Staff Report to the Zoning Administrator

Application Number: **08-0387**

Project Description: Proposal to demolish an existing market/residence building and construct a new two story building with office use on the first floor and two apartments on the second floor. The new building is to be 3,935 square feet total area. The project will combine two parcels, APN 026-091-09 and APN 026-091-32, into one.

PERMIT CONDITIONS / ADDITIONAL INFORMATION

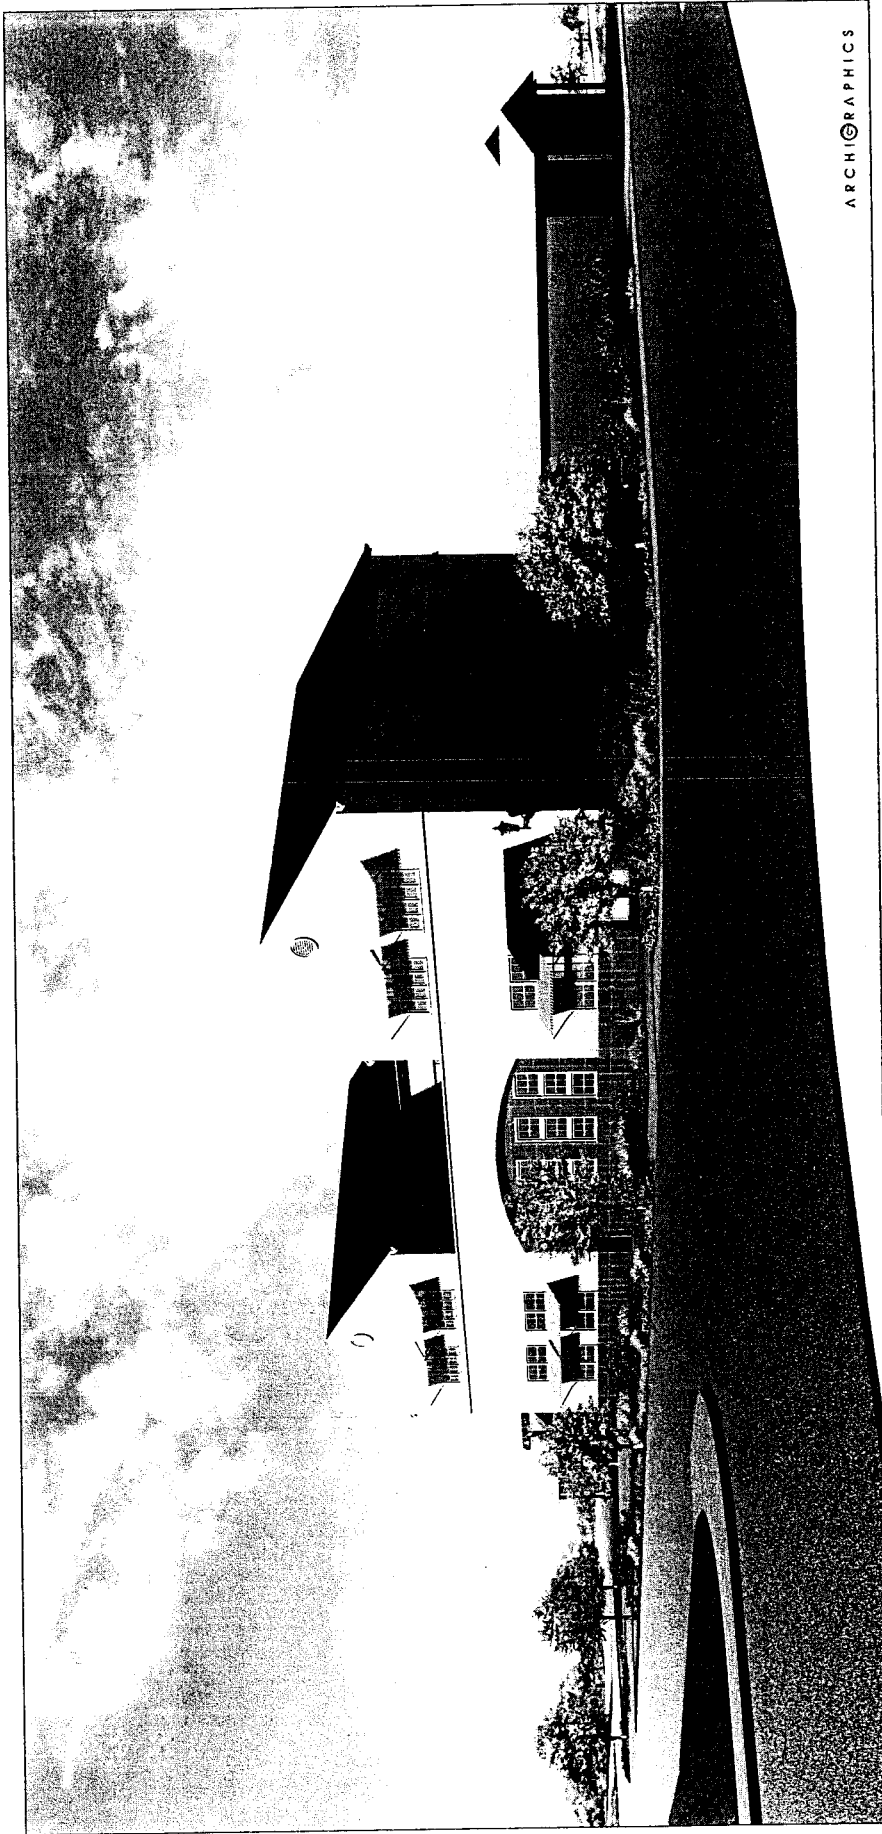
- *The entry facing Seventh Avenue should be eliminated as it only goes in to a private office and does not serve as a public entry.*
- *In previous proposals, the entry at the parking lot was conditioned to be rotated diagonally such that it could serve both the parking lot and Seventh Avenue. This proposal should be similarly conditioned.*
- *The vine pockets and vine selection shown on the western edge of the property between the fence and the driveway should be adequate to provide a "green wall" in a short time. These vines must be irrigated.*
